STAFF RECOMMENDATION

1022 Acklen Avenue

July 18, 2018

Application: New construction – Addition and Outbuilding; Setback Determination

Figure 3. Sanborn map c. 1957 showing original footprint

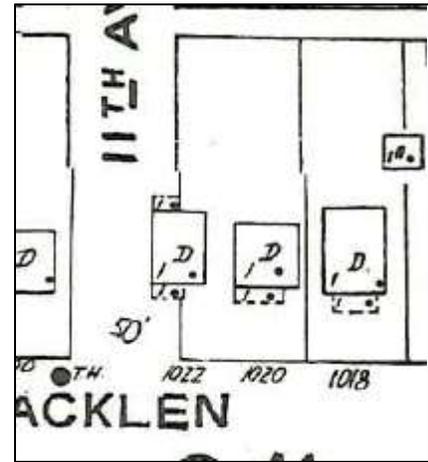
Most of the rear wall of the existing structure is proposed to be removed for the new construction. This section of the house has already been added onto (see Figure 2). Staff finds the demolition appropriate because it is not an original or significant portion of the building (Figure 3), and its removal will not be detrimental to the architectural integrity of the building or the district. Additionally, four bays

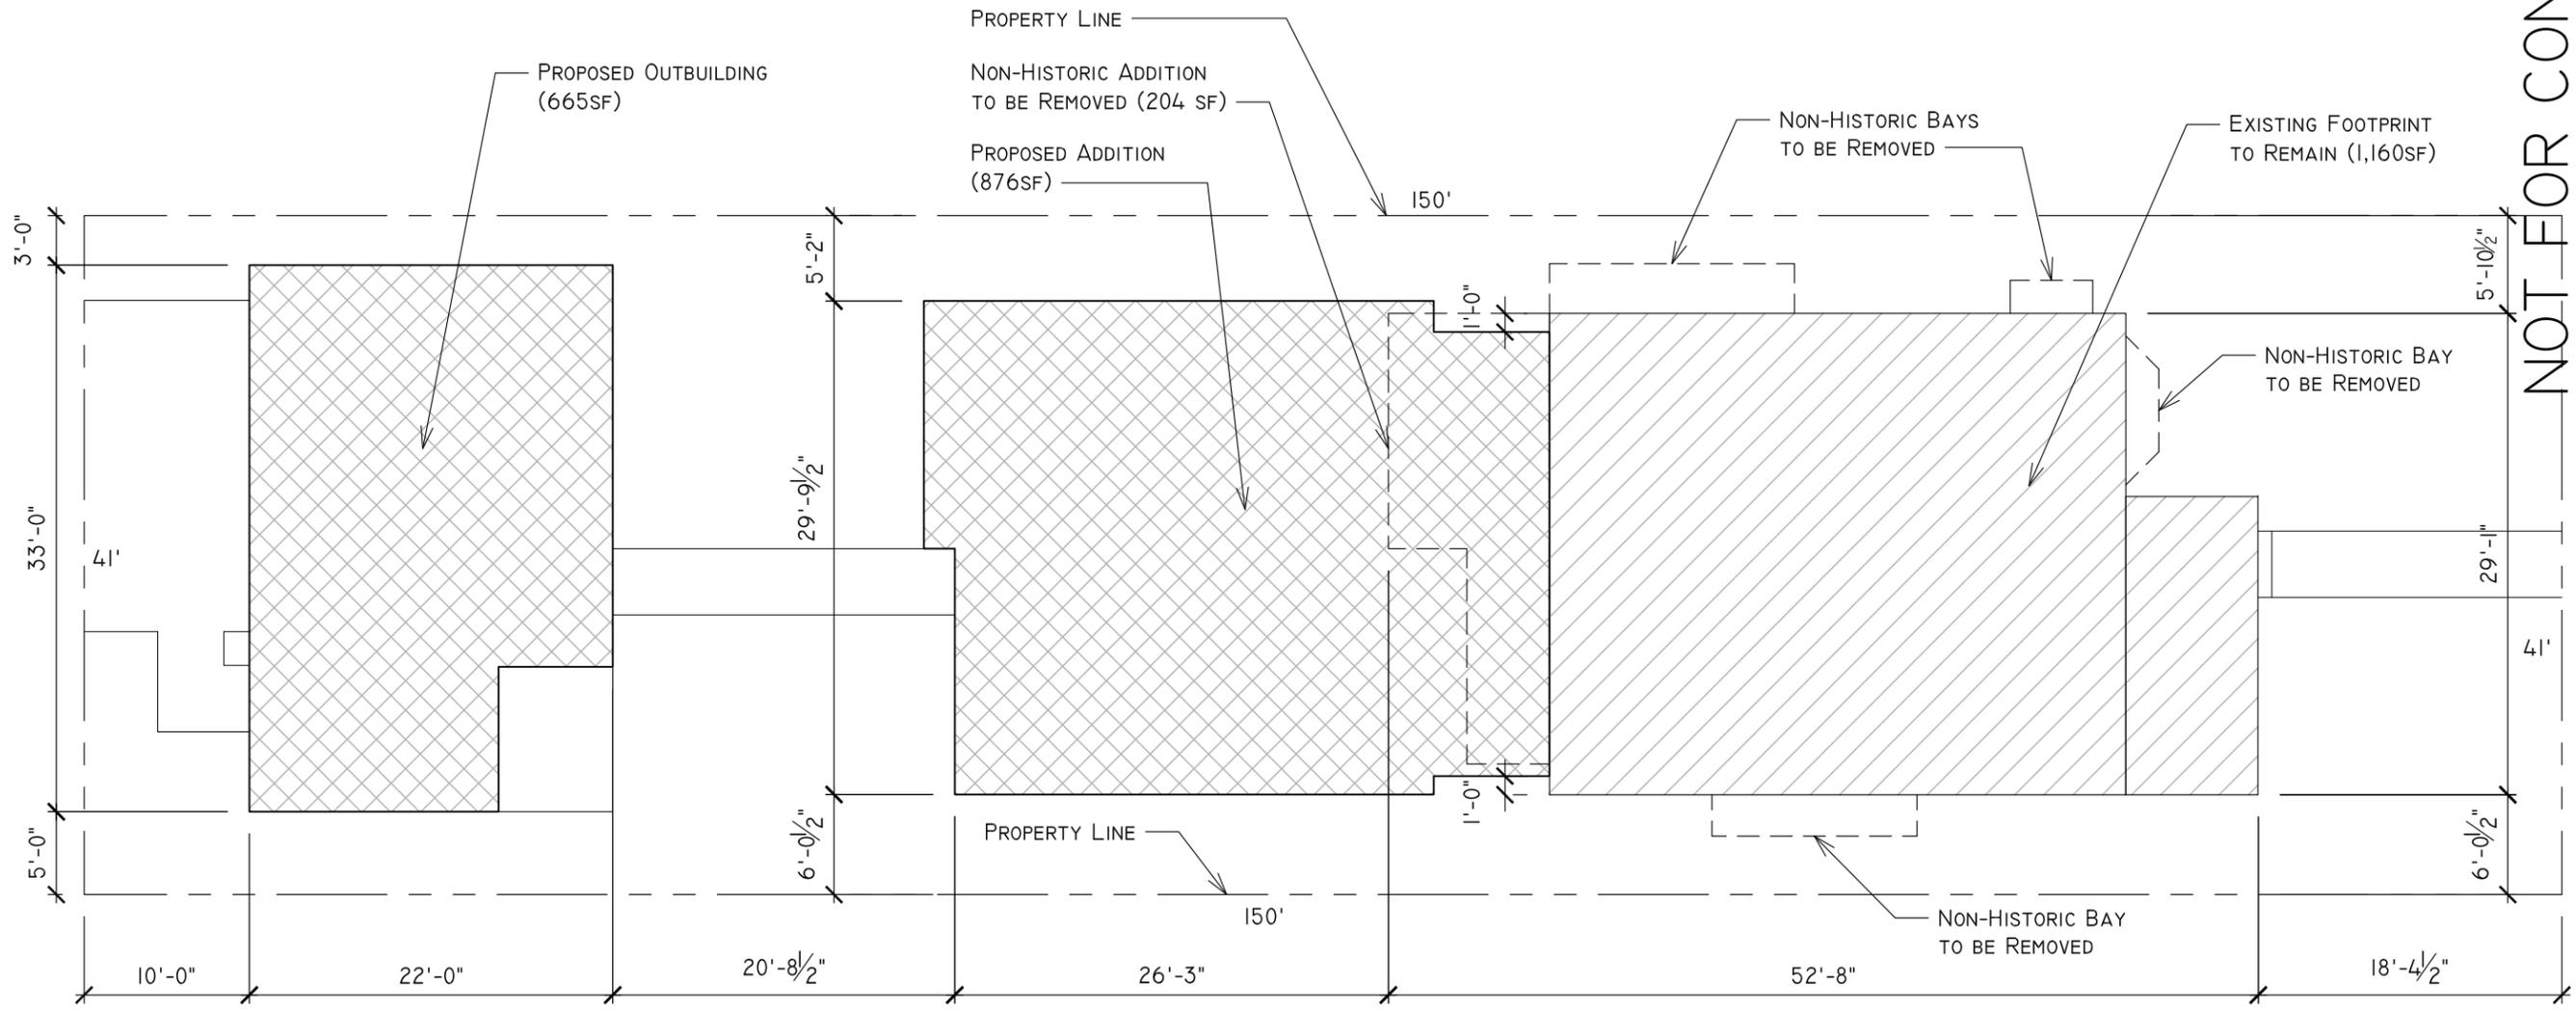
MINIMUM	PROPOSED
Space between principal building and DADU/Garage	20'	20' 8"
Rear setback	5'	10'
L side setback**	3'	5'
R side setback**	3'	3'
How is the building accessed?	From the alley or existing curb cut	Alley

Existing conditions (height of historic portion of the home to be measured from finished floor)	Potential maximums (heights to be measured from grade)	Proposed (should be the same or less than the lesser number to the right)
Ridge Height	20' 2"	25'	19' 11"
Eave Height	9' 3"	10'	9' 5"

With the condition that the eave height is reduced, and staff approval of windows and doors, the project meets section III.H of the design guidelines for outbuildings.

1 SITE PLAN

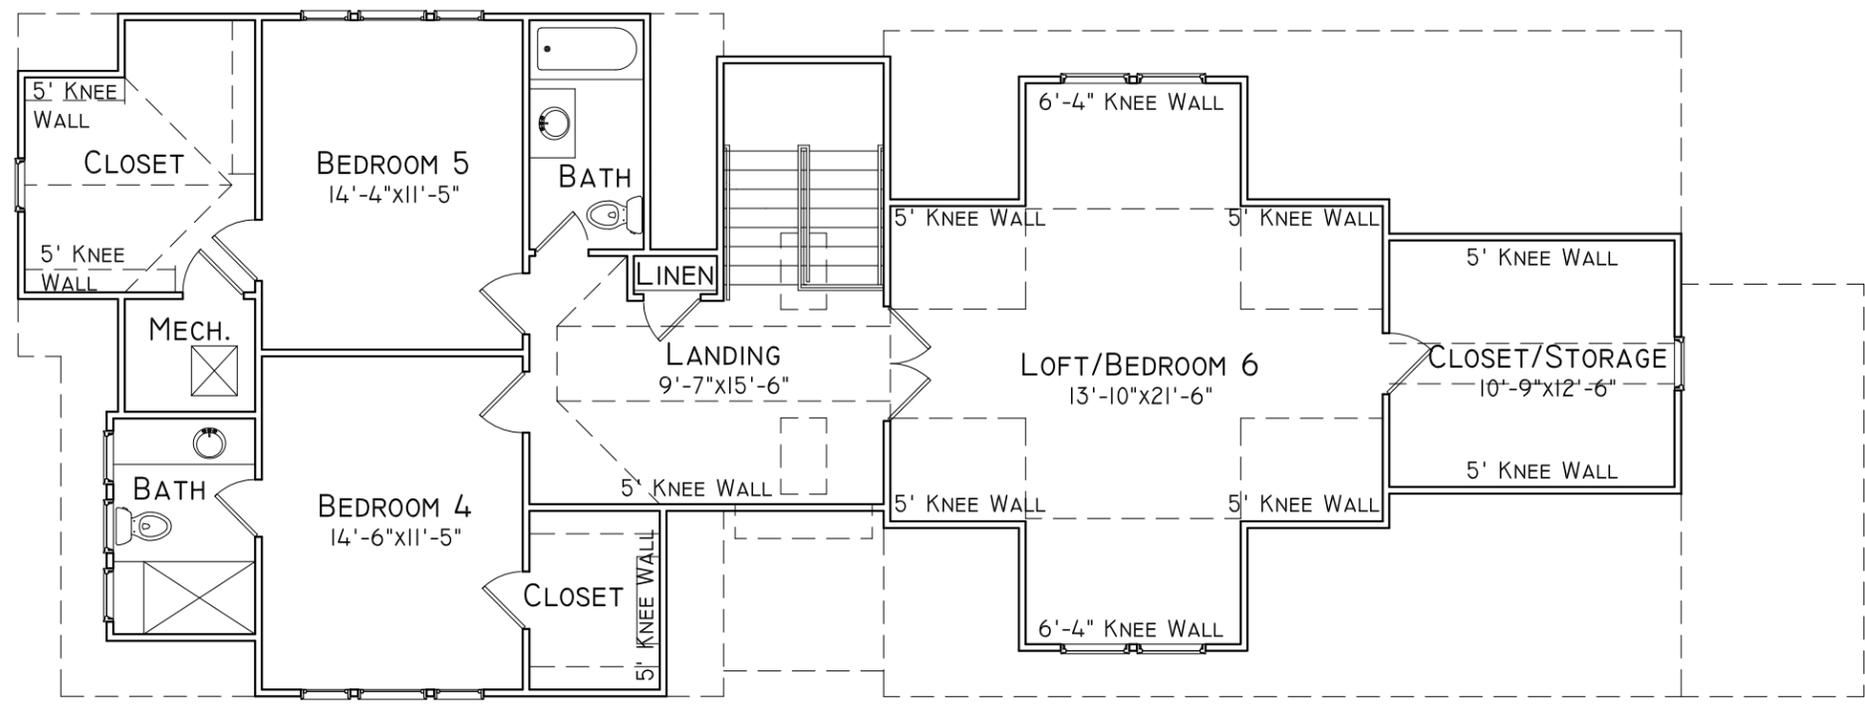
Setbacks: The addition will be approximately six feet (6') from the left side property line and five feet, ten inches (5' 10") from the right side property line. On the left street-side, the addition will not meet the required ten feet (10') required by base zoning for a corner lot. The addition will not exceed the width of the existing building, which is currently six feet (6') from the property line on its left side. Staff recommends approval of the side setback determination to six feet (6') since it is an existing condition. The rear setback will be approximately fifty feet (50'), which meets base zoning requirement of twenty feet (20'). Staff finds that the addition meets section III.C of the design guidelines for setbacks.

Appurtenances & Utilities: The site plan does not indicate the location of the HVAC and other utilities. Staff recommends that the HVAC be located on the rear façade, or on a side façade beyond the midpoint of the house. The project meets section III.I for new construction-utilities.

FLOOR PLANS

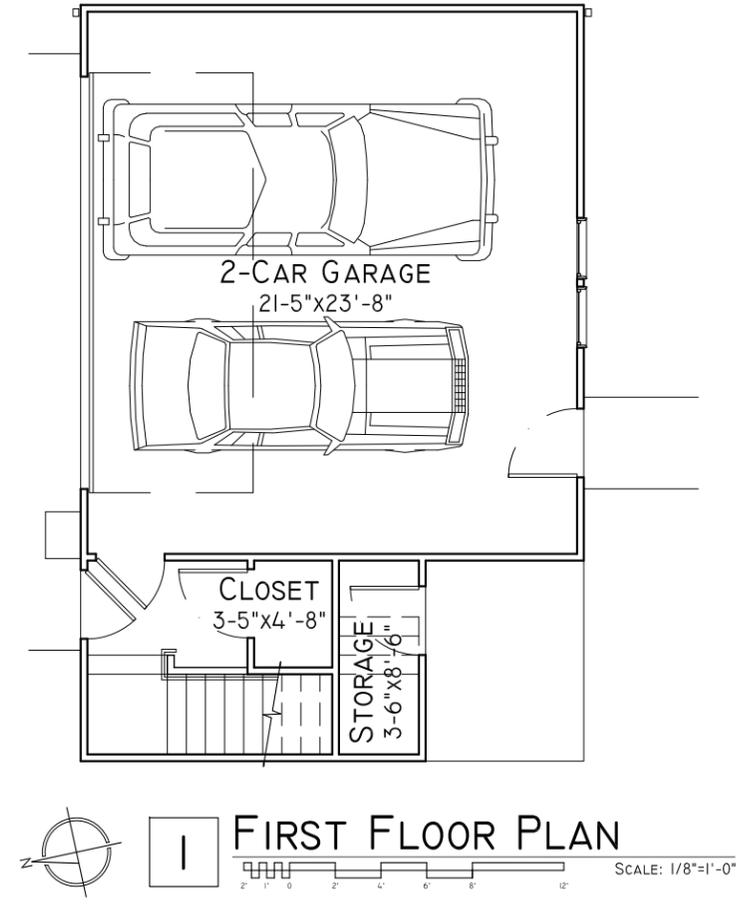
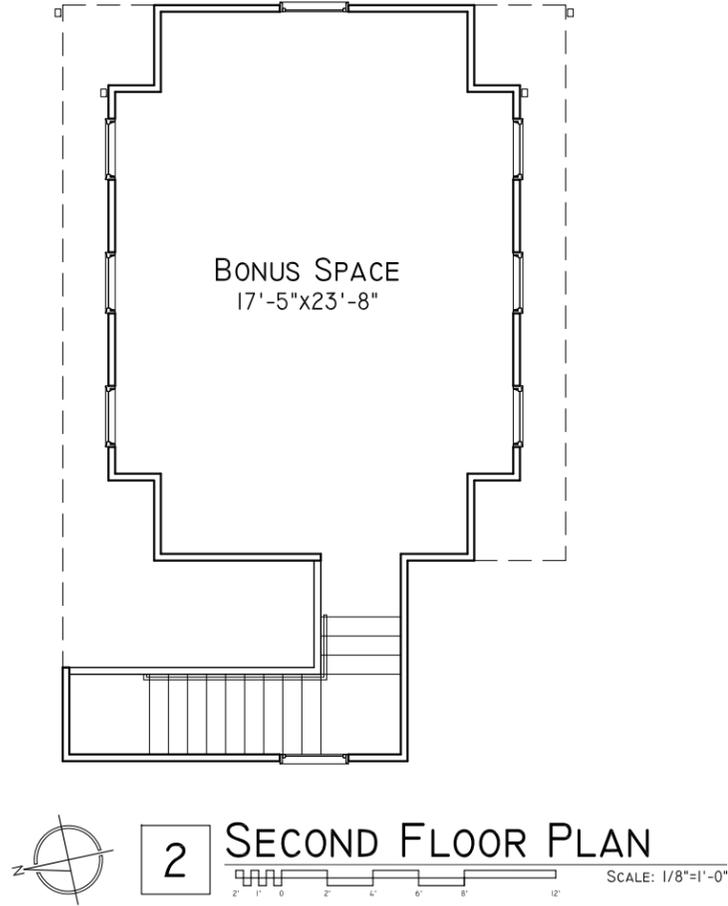
Height & Scale: The addition will be situated at the rear of the historic building. It will inset one foot (1') at the rear corners, and then will return to the same width as the house. The Commission has required two-story or one and a half-story additions to inset two feet (2') to distinguish the new construction from the existing. Accordingly, Staff recommends the addition inset two feet (2'). The peak of the addition is three feet, eleven inches (3' 11") taller than the ridge of the house. The Commission has recently required additions to be no more than two feet (2') taller than the existing structure. In this case, the existing house has a modest ridge height of twenty feet (20'). For this reason, Staff finds the massing to be compatible. With the condition that the addition inset two feet (2') the project meets Sections III.A and III.B for new construction and IV.B for additions.

1. The addition's inset is increased to two feet (2');
2. The new front window is a paired window with a 4"-6" mullion between and to the same dimensions as the existing paired windows on the front left side;
3. Staff approve the final details, dimensions and materials of windows, doors, garage doors and color of roofing material prior to purchase and installation;
4. HVAC shall be located behind the house or on either side, beyond the mid-point of the house.
